Our Ref: 890815/L03/GXA

RE: DC/24/1676 – New Place Nurseries, London Road, Pulborough, West Sussex, RH20 1AT

LLFA Comments

Client BDW Southern Counties		
Project Name New Place Farm		
Description Monitoring Well Location Plan		
Project ID LP3824	Drawing no. 22201	Revision C01
File name LP3824-LS-222-XX-D-G-22201-C01		
Dimensions m	Scale 1:2,000	Size A3
0 20 40 60 80 100 m

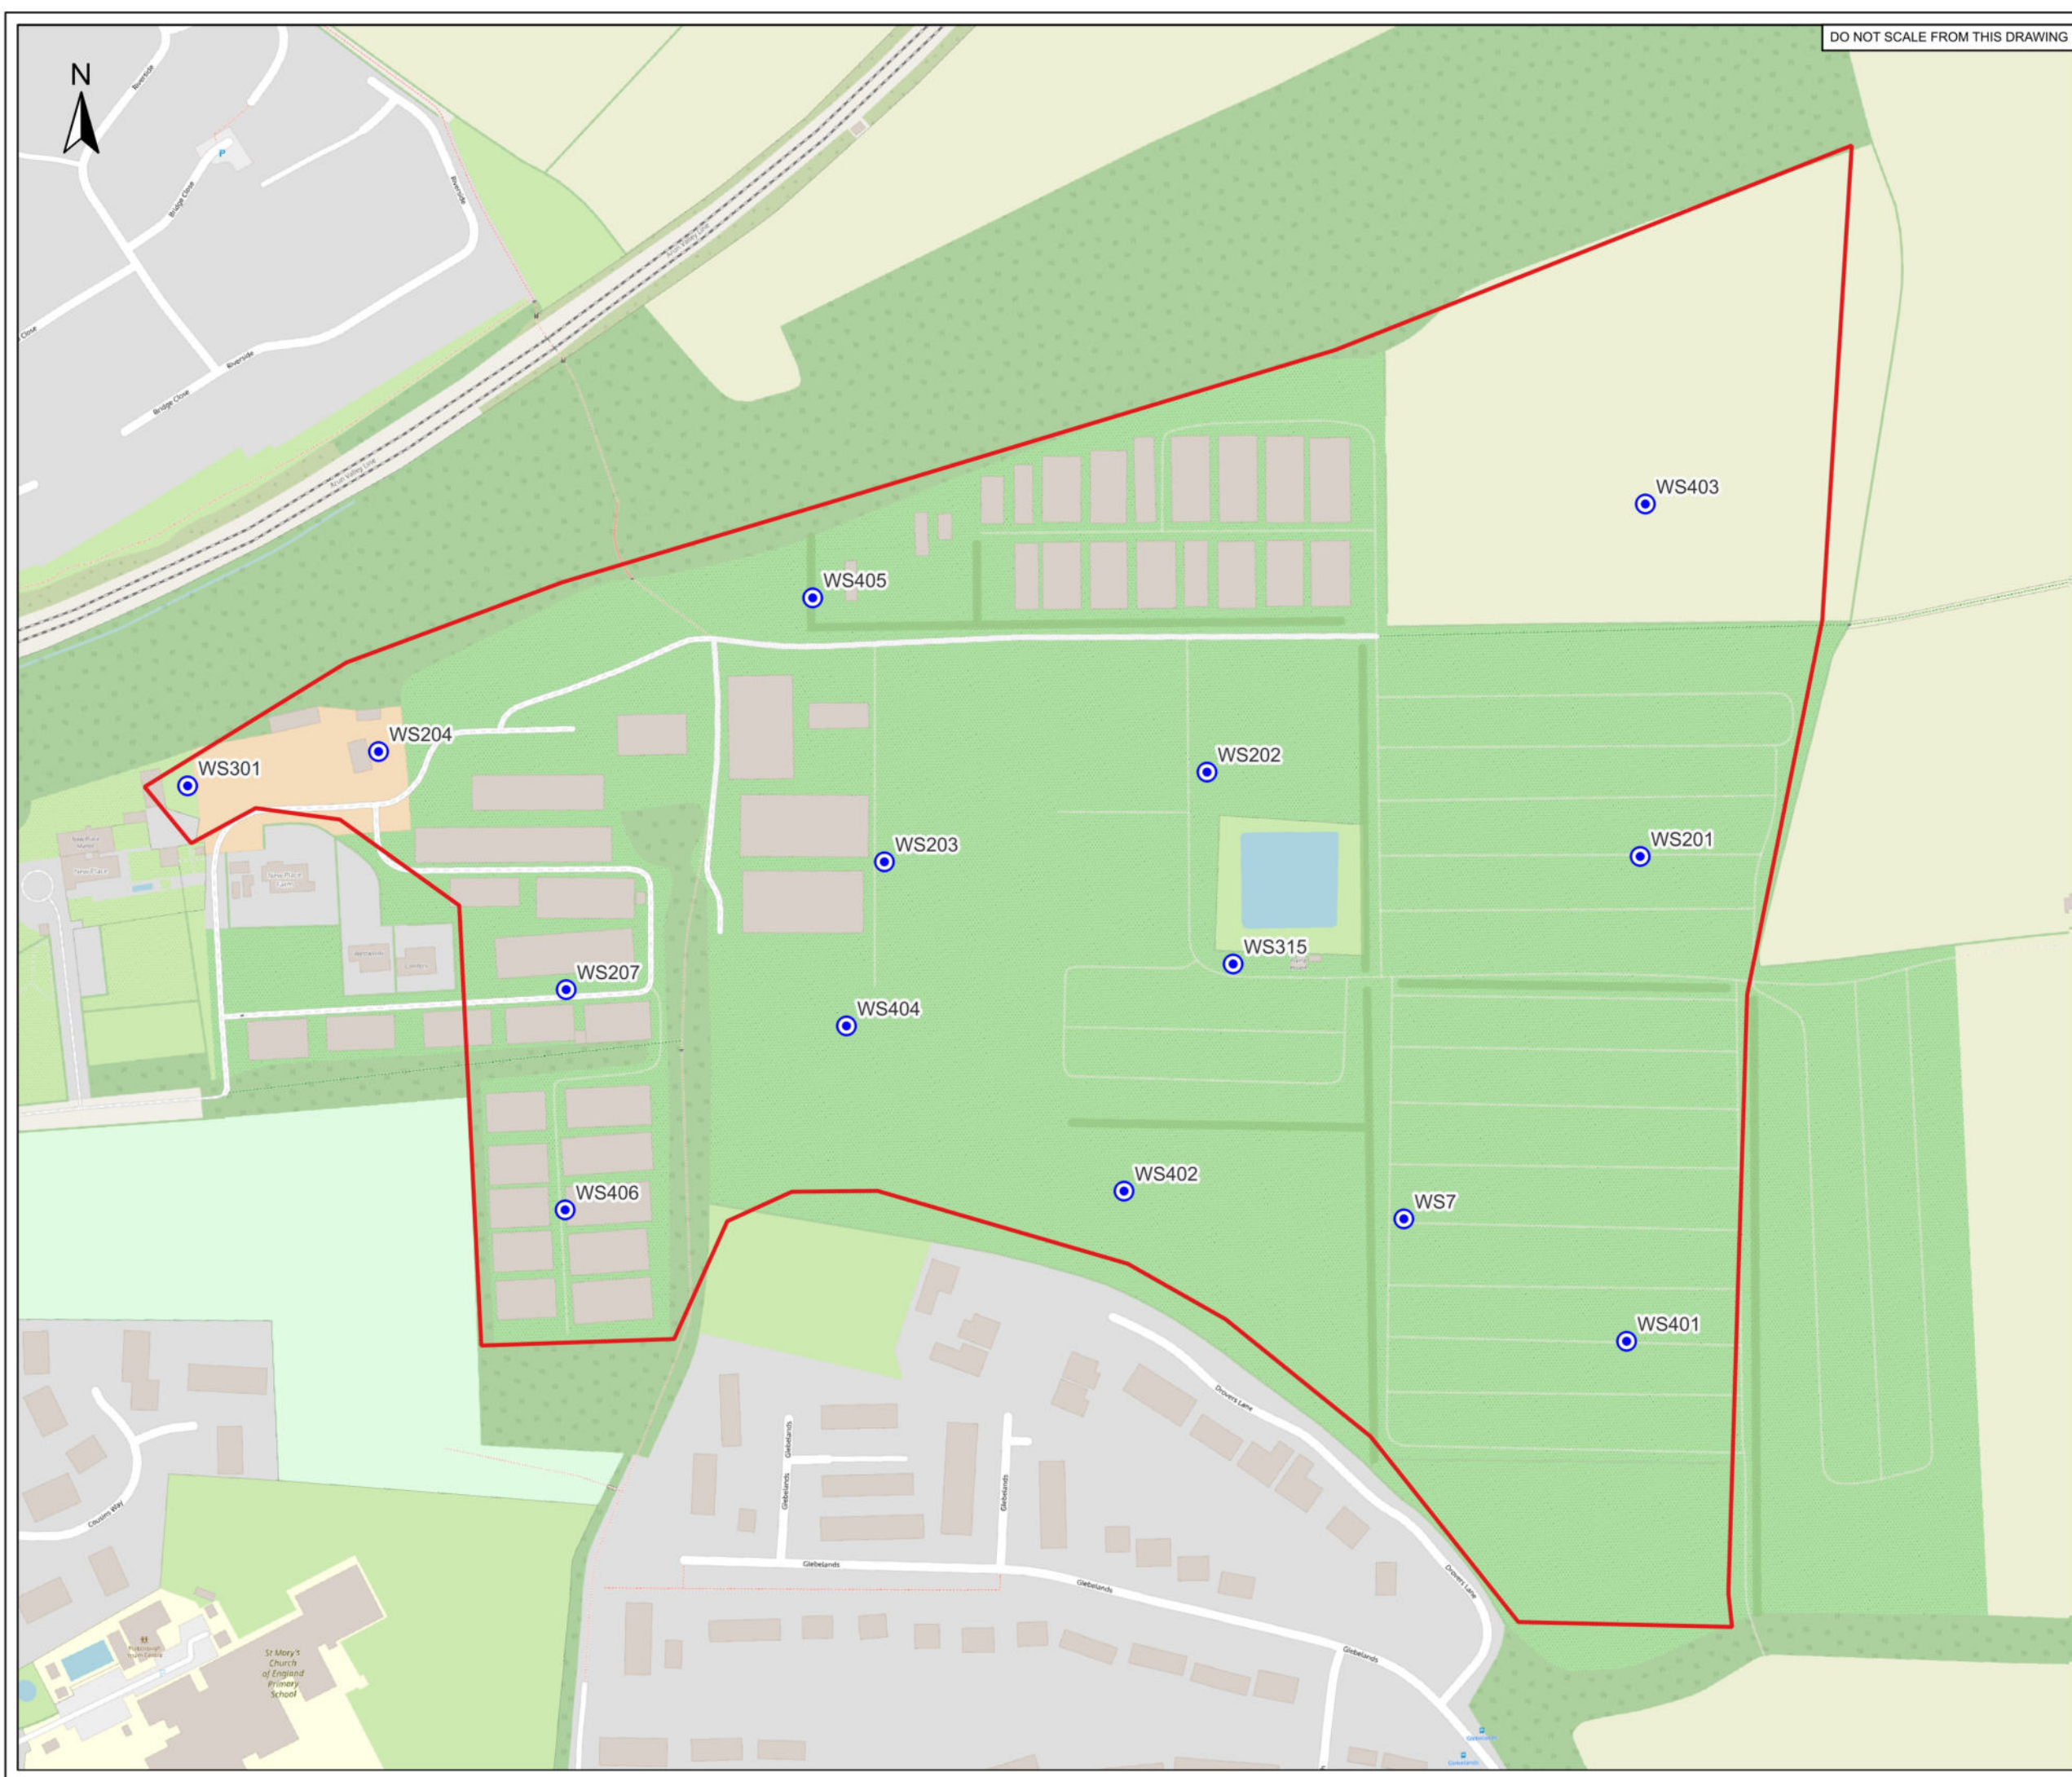
6. *It is noted that no winter groundwater monitoring has been completed. As this is likely to be required for detailed design for the surface water drainage conditions, we would suggest this begins very soon, given the time of year.*

Groundwater monitoring wells were installed in April 2024 (WS301, WS315) and a further 6 monitoring wells were undertaken in October 2024 specifically for Winter water level monitoring (WS401-WS406). The Groundwater monitoring report is located in Appendix C.
